Re: 53-55 Vastern Road - Daylight and Sunlight review response

Eb7 have been instructed to respond to the comments in the BRE review of the daylight and sunlight report relating to the proposal at 53-55 Vastern Road. This review is dated 7th of April 2020 and responds to the Daylight and Sunlight report dated by eb7 dated the 19th December 2019.

Fig. 4: First Floor Plan

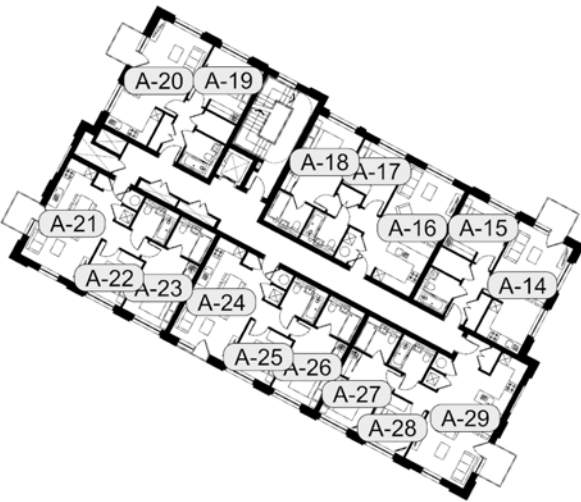
- A08, A24, BC06, BC13 – Overhanging balconies removed
- BC09 and BC39 – Overhanging balconies removed and increased glazing to the room
- BC 50/51 – Rearranged layout – bedroom and living room have been flipped in order to maximise light to living room
- BC56 - Increased glazing
- EFG13 – Introduction of an additional window
- EFG18 – Massing rearranged to include a window

- A08 (LKD) – 1.1%
- A24 (LKD) – 1.1%
- BC13 (LKD) – 1.3%
- BC39 (LKD) – 1.4%

- BC06 (LKD) – 1.9%
- BC09 (LKD) – 0.9%
- BC50 (Bedroom) – 1%
- BC51 (LKD) - 1.2%
- BC56 (LKD) – 1.9%
- EFG13 (LKD) – 1.5%
- EFG18 (LKD) – 1.8%

Fig. 7: BRE's Sun on Ground

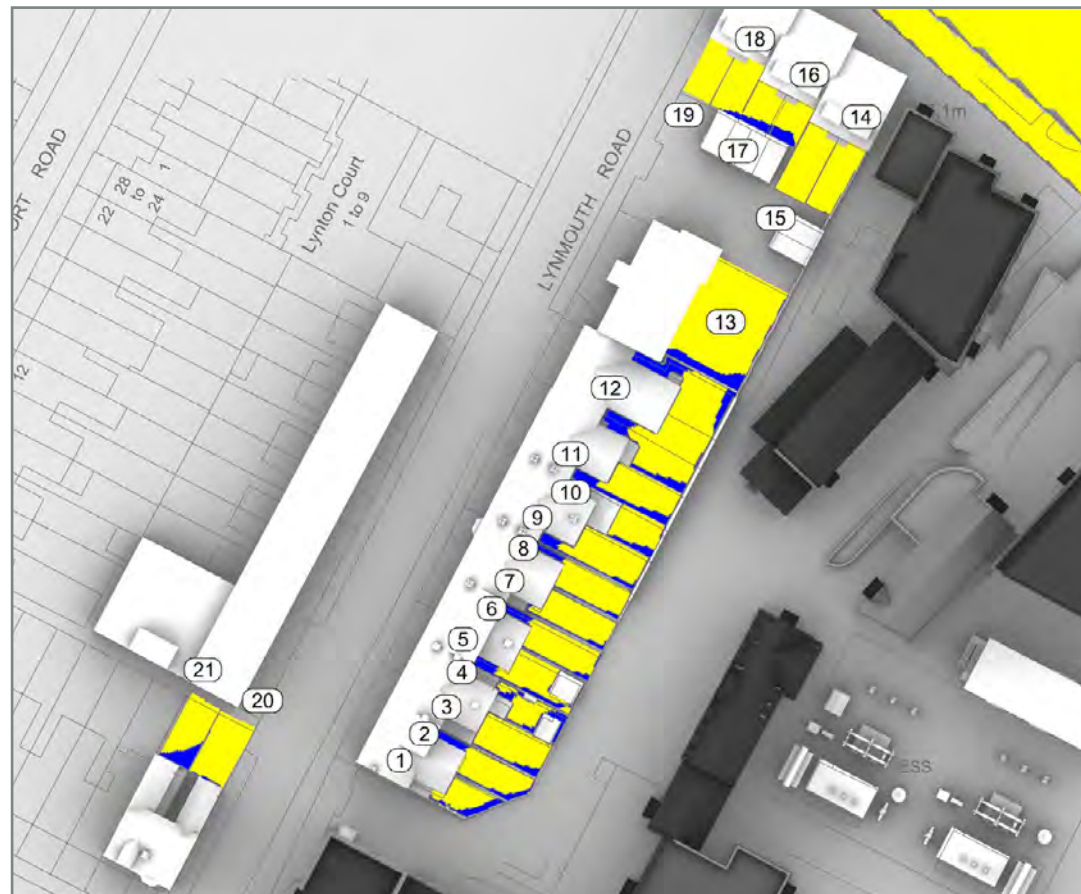
The BRE review suggests that the effect of the proposal on shadow to the garden of 2 Lynmouth Road would be Major Adverse and 4 Lynmouth Road would be Moderate Adverse. These neighbours sit next to each other to the north of block A. As stated in the BRE review, 2 Lynmouth Road is a small garden with walls around it that limit sun. This makes it very sensitive to overshadowing effects, especially where massing is proposed to the south.

In addition to the standard tests in the BRE guidance, we have provided a further test in appendix 3 to show light levels to the gardens serving 2 and 4 Lynmouth Road on June 21st. This Sun on Ground test has been run to considers the area of these gardens that will see at least 4 hours of sunlight on this date with the proposal in place. The analysis shows that these gardens see 4 hours or sunlight on the 21st of June across 87.2% and 90.5% respectively. We feel that this demonstrates that the cutbacks to the scheme have been successful in maximising direct sunlight to these gardens when it would be most valued in the summer months.
